# 1001 JOHN ST

SEATTLE WA, 98109  
DPD# 3020563

**WEST DESIGN REVIEW BOARD:**  
DESIGN RECOMMENDATION 2 MEETING  
JULY 13, 2016

Recommendation Response Comments Matrix

6 Tower Separation 23.48.245  
Proposed Departure Condition

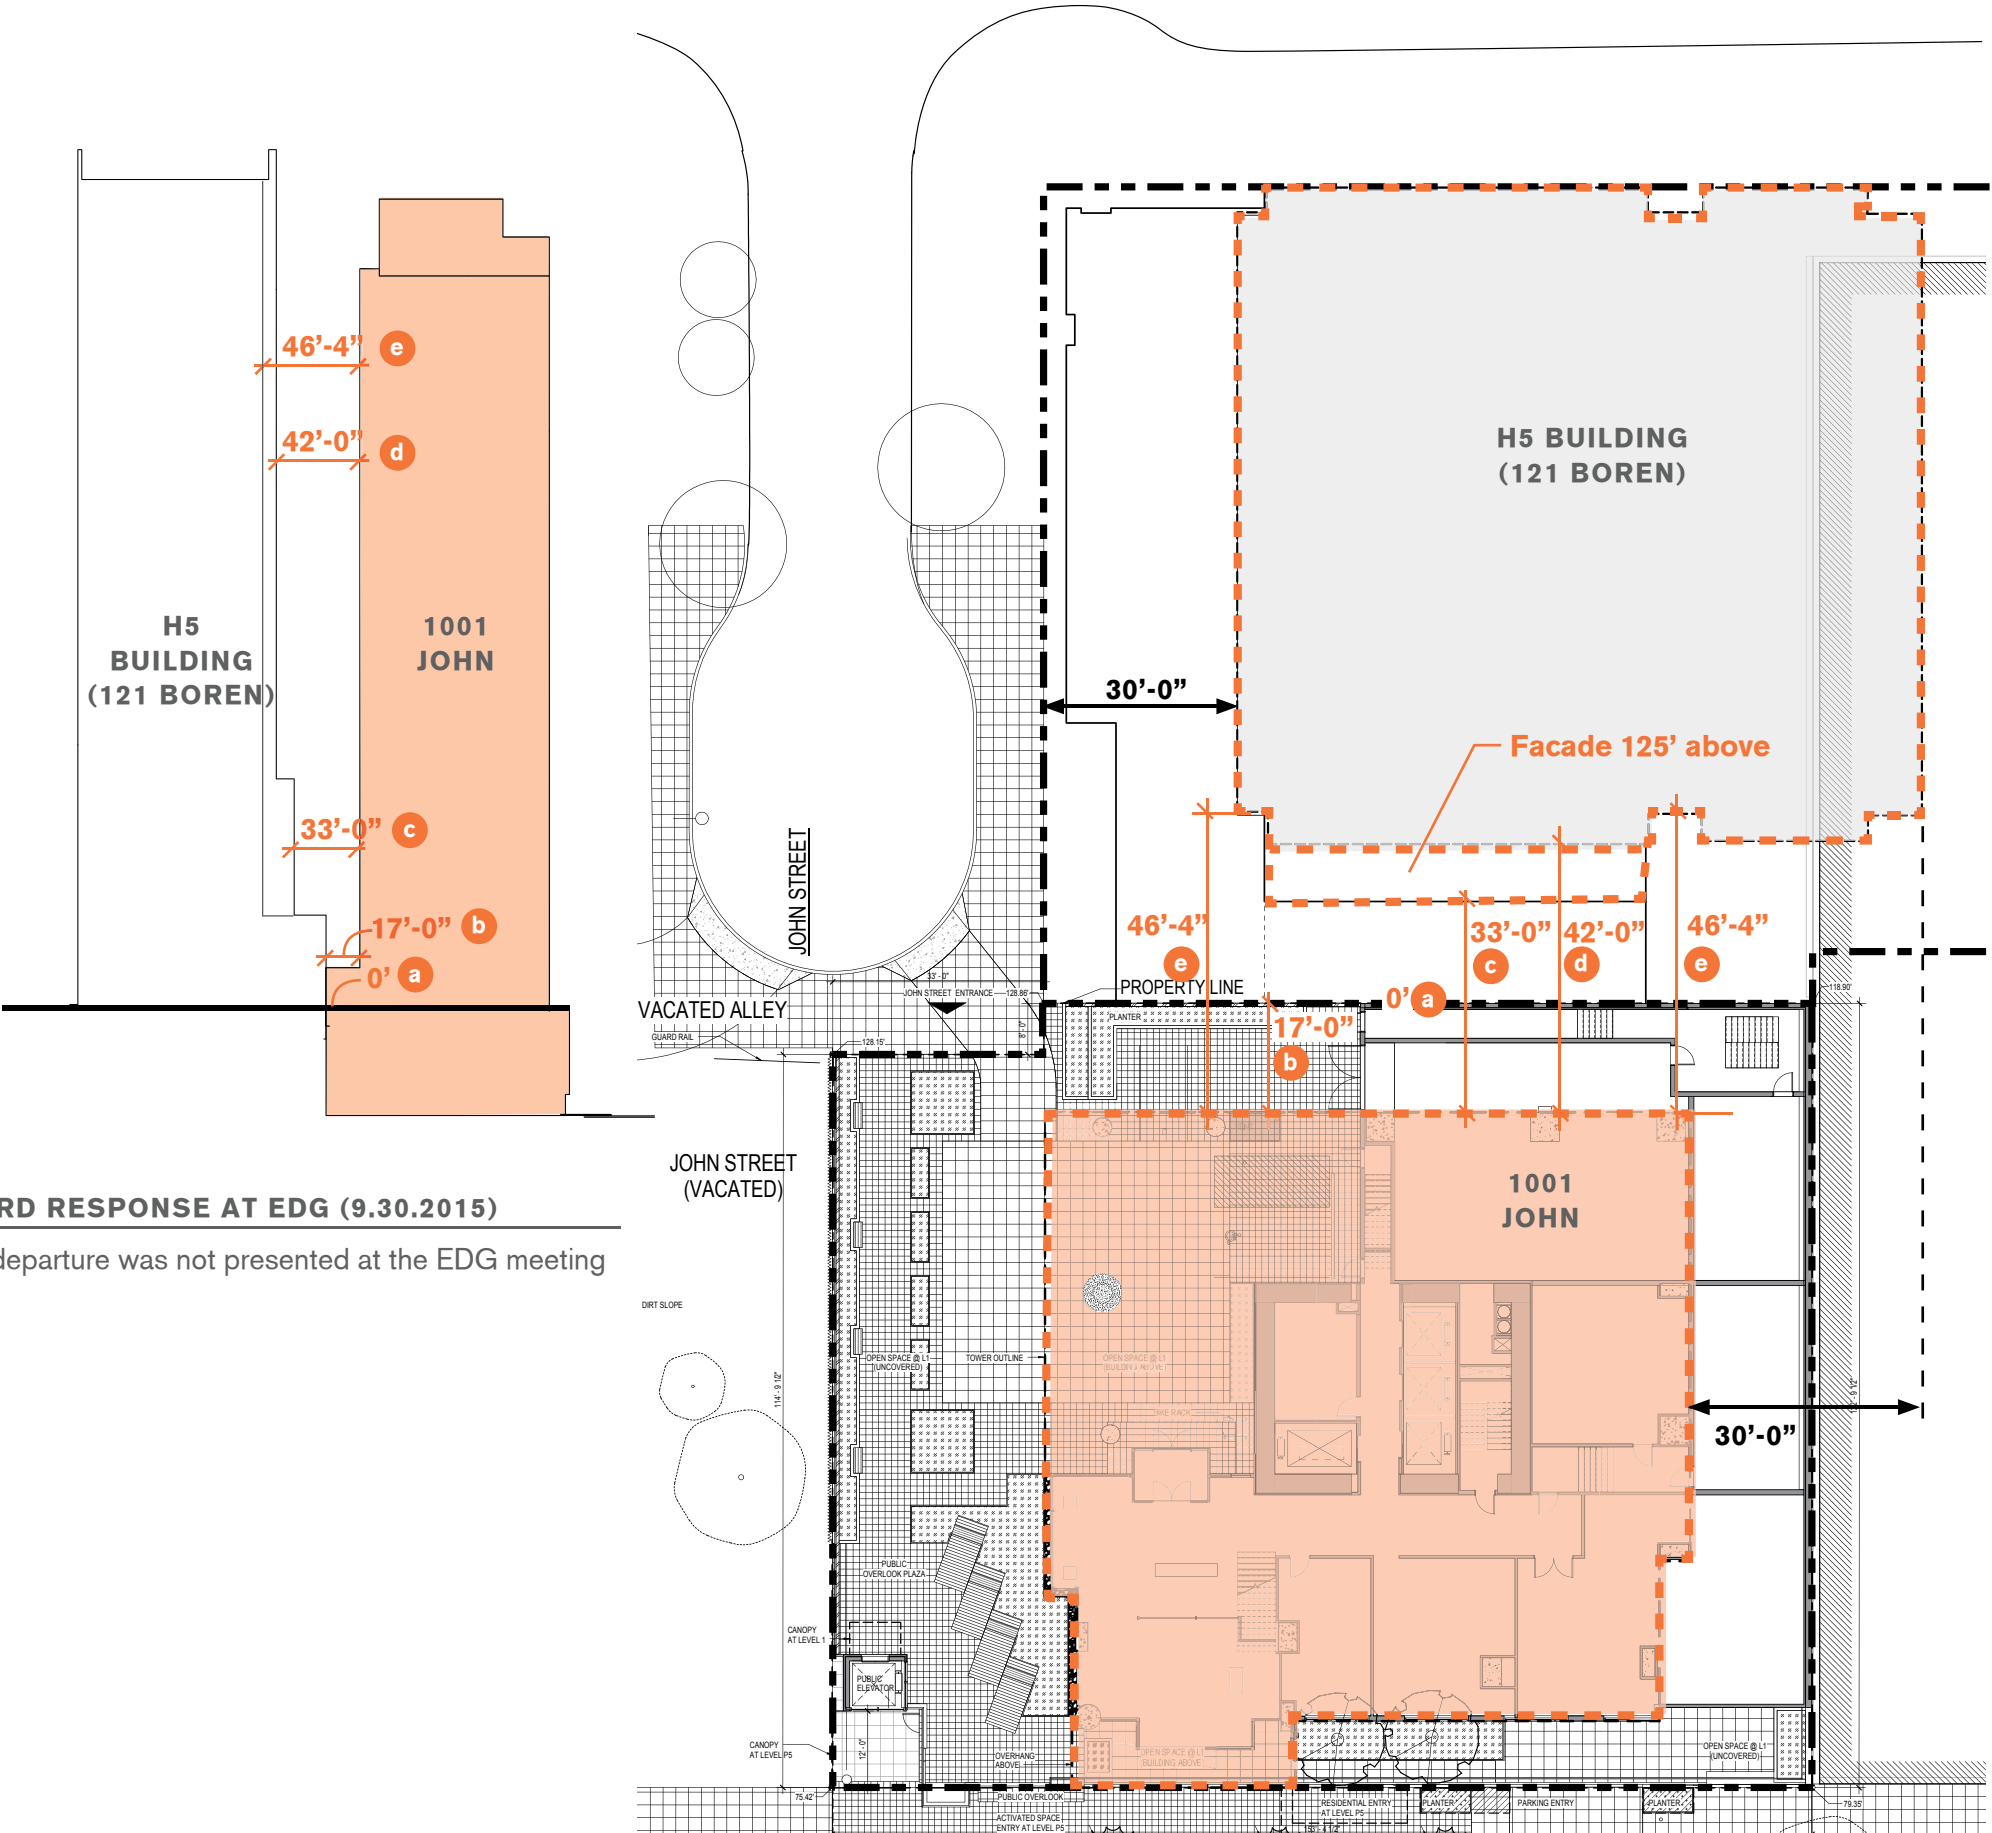
Tower separation less than 60' based on latter applicant's H5 Tower location (121 Boren #3021279). The project requests the following tower setbacks from 121 Boren (H5 Tower):

- a. 0'
- b. 17'
- c. 33'
- d. 42'
- e. 46'-4"

Following the direction from our EDG meeting and the design review board we have kept the tower out of the vacated John Street ROW. Along with staying out of the vacated John Street ROW we have voluntarily moved the tower as far west 7' and north 5' as we can to separate it from the property to the east (H5 Development project #3021279). The result of this tower move eliminated half of the residential units in the podium levels. Due to the size and geometry of our site there are very few tower location options and these were presented at our EDG meeting. The proposed tower stands 17'-0" off the east property line and 15' or more off the south property line. Based on the drawings submitted by H5 on 3-23-16, this would create a tower separation of 42' and 46' above 125' and 33' separation below 125'. Tower separation could change if H5 revises their design. Towers are currently offset 30' north/south.
